Draft decision

**ElectraNet
transmission determination
2008–09 to 2012–13**

9 November 2007

Figure 2.1: Comparison of ElectraNet’s 2002 allowance and its actual capex profile

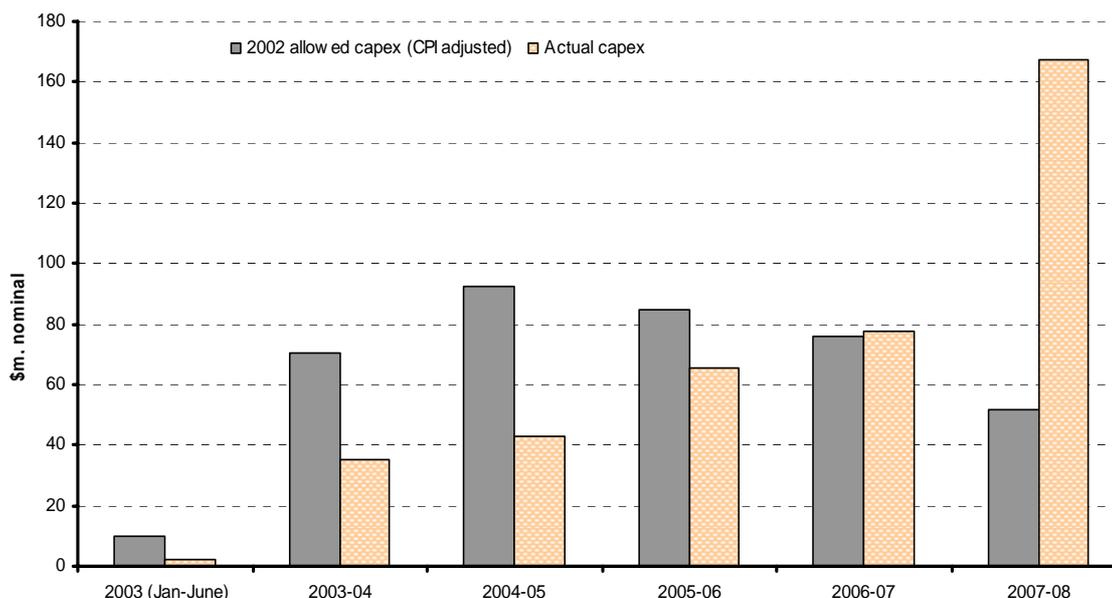
The AER notes that ElectraNet’s actual capex spending profile is very different to that approved by the ACCC in its 2002 revenue cap decision (see figure 2.1). Expenditure for projects such as the South East – Snuggery (scheduled for commencement in 2004–05) and the Playford relocation (scheduled for commencement in late 2002) were delayed such that the majority of ElectraNet’s capex occurred within the last three years of the current regulatory period.

The AER considers that, even though ElectraNet did not follow its forecast spending profile, the explanations provided in its proposal are reasonable. The AER notes that ElectraNet stated that a number of project deferrals offset the need to undertake a higher than forecast asset replacement program during the current regulatory period. These issues are discussed below.

Figure 3.1: ElectraNet’s proposed landowner compensation cost methodology

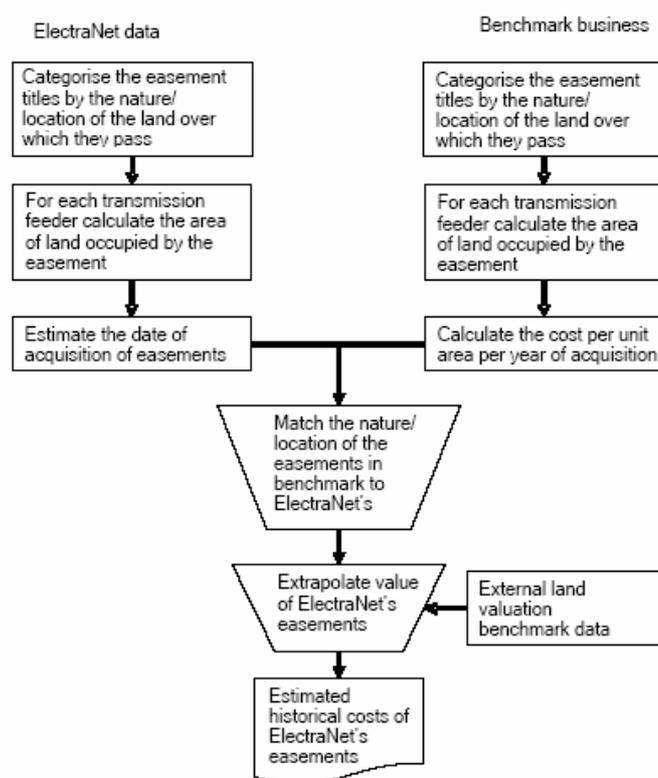
Figure 3.1 illustrates the methodology for estimating the proxy historical cost.

The AER has investigated ElectraNet's methodology and considers that it is sound. It considers that the model's key input information and assumptions are appropriate and the final cost outcomes are acceptable in the context of limited historic information. Accordingly, the AER accepts ElectraNet's methodology regarding landowner compensation costs. Based on this methodology, the AER agrees that the easement compensation cost of \$29 million should be added to the RAB.

Figure 6.1: Controllable opex per kilometre of line (\$m, 2007–08)

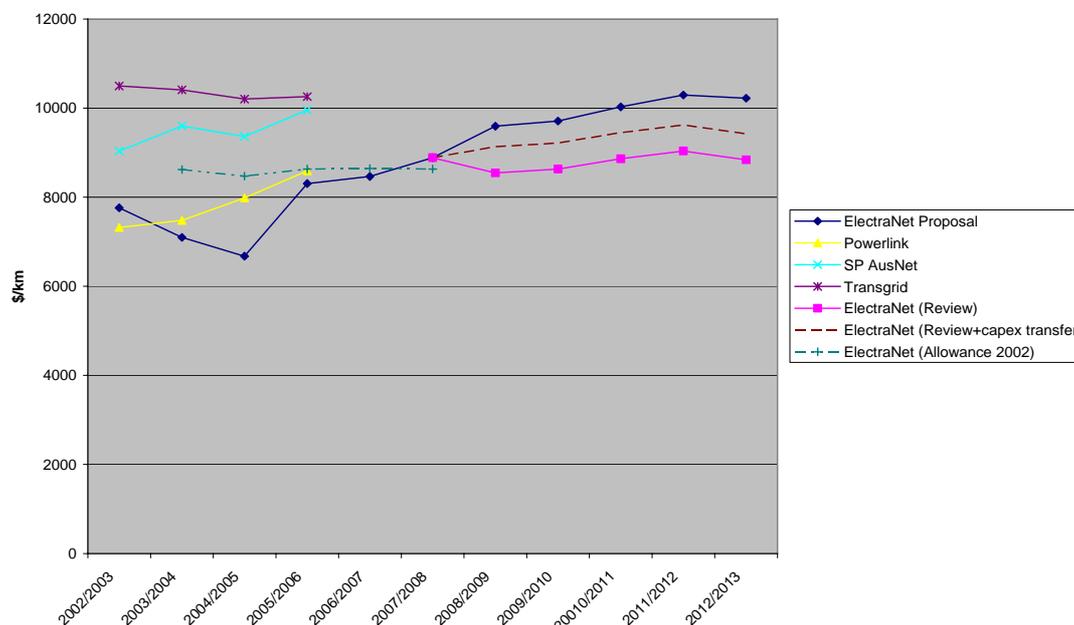
The combined impact of SKM’s recommended adjustments is shown in figure 6.1. It presents ElectraNet’s controllable opex as a proportion of line length, and also shows a comparison with other Australian TNSPs. SKM stated it used the opex/line length ratio in its comparisons with other TNSPs to take into account the fact that ElectraNet has a geographically extensive network with relatively low load. Figure 6.1 shows that while ElectraNet’s proposed opex allowance resulted in a steep increase in the

opex/line length ratio, implementing SKM’s proposed adjustments leads to a fairly stable ratio, throughout the next regulatory control period.

Figure 6.2: Opex project expenditure 2003–04 to 2012–13 (\$2007–08)

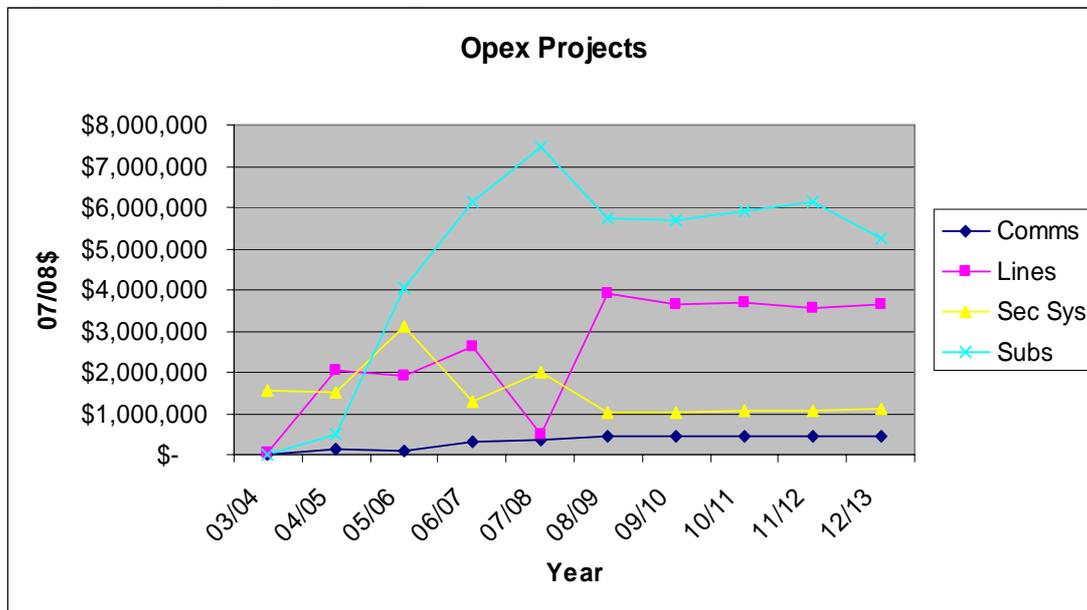
SKM suggested that the historical costs should be measured over the period spanning the last five years, rather than the period proposed by ElectraNet, to ensure the forecast costs better reflect likely future costs. Figure 6.2 shows a marked increase in opex project costs in 2005–06 and this increase is captured when using SKM's recommended historical cost measure.

The AER agrees with SKM’s recommendation that the transmission lines opex project escalator should be calculated using the most recent five year historical cost data and that the 10 per cent escalator proposed by SKM represents a reasonable proxy for these costs. This adjustment is reflected in the AER’s opex maintenance projects forecasts.

Figure C.1: ElectraNet’s average asset lives as a percentage of asset life

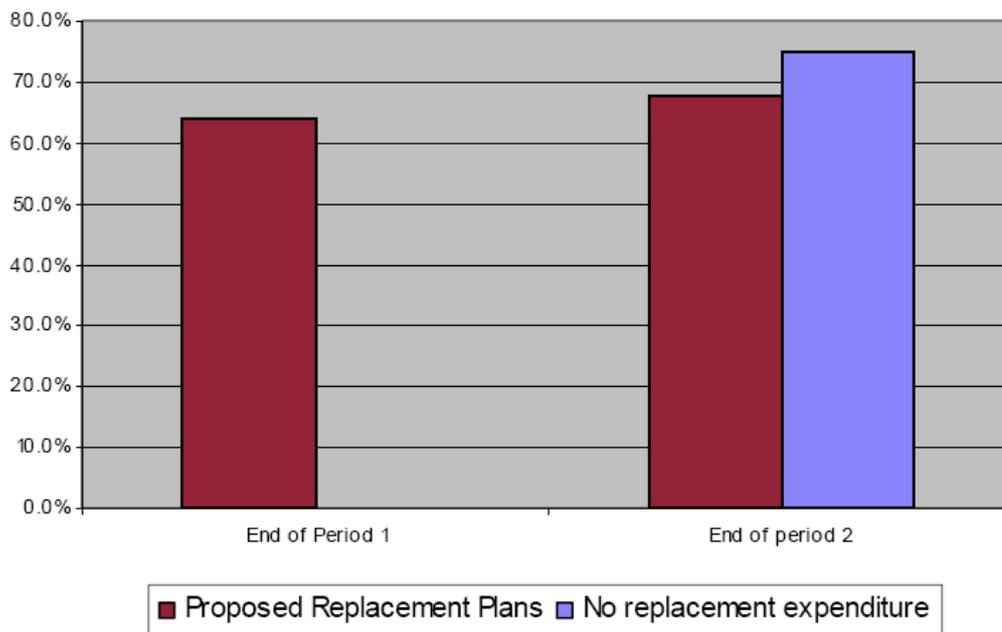
The ECCSA stated that the AER should consider the effect that the replacement capex program has on ElectraNet’s average asset life.⁴⁹² The AER requested ElectraNet to provide information showing the effect of the replacement capex on its average asset age. Figure C.1 shows that ElectraNet’s average asset age is not reducing due to the proposed replacement program. Period 1 denotes the current regulatory period and period 2 is the next regulatory control period.
